### **TECHNICAL SERVICE BULLETIN**

| SUBJECT:  |   | No: <b>TSB-07-42A-007</b>                              |  |
| <b>SUNROOF WATER LEAK</b>                           |   | DATE: <b>March, 2007</b>                               |  |
|   |   | MODEL: <b>2006-07 Eclipse</b>                          |  |

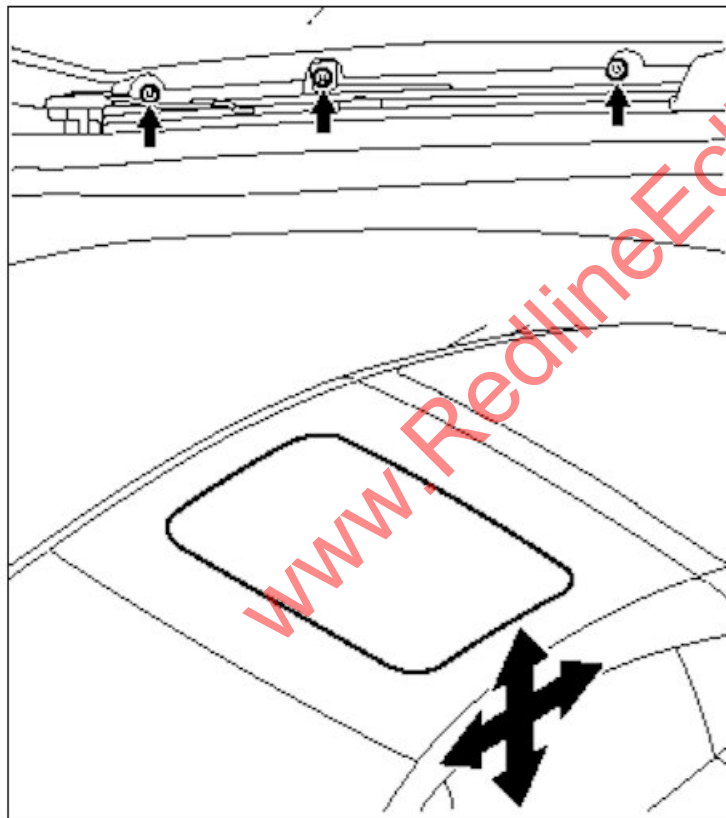
Water leakage may occur due to water getting past the sunroof glass seal. Leakage may be evident from the sunroof switch, or at the SRS logo covers on the 'A' pillar trim. Follow the procedure below to add sunroof lid guide covers to repair this condition.

1. Remove the sunroof glass. Follow the service manual procedure in Group 42A of the appropriate service manual for removal instructions.
2. Remove the headliner. Follow the service manual procedure in Group 52A of the appropriate service manual for removal instructions.
3. Disconnect the four sunroof drain tubes.
4. Remove the complete sunroof assembly from the vehicle and place it onto an appropriate work surface.
5. Clip the left hand and right hand sunroof lid guide cover (listed in the PARTS INFORMATION section of this bulletin) onto each front corner as shown.
6. Reinstall the sunroof assembly into the vehicle.
7. Reattach the four drain tubes. Insure that the tubes are pushed all the way onto the sunroof drain nipples.

8. The glass should be centered in the vehicle and 1 mm below the roof surface along the front edge and flush with the roof surface along the rear edge. If the sunroof glass is not in the proper position, adjust as necessary.
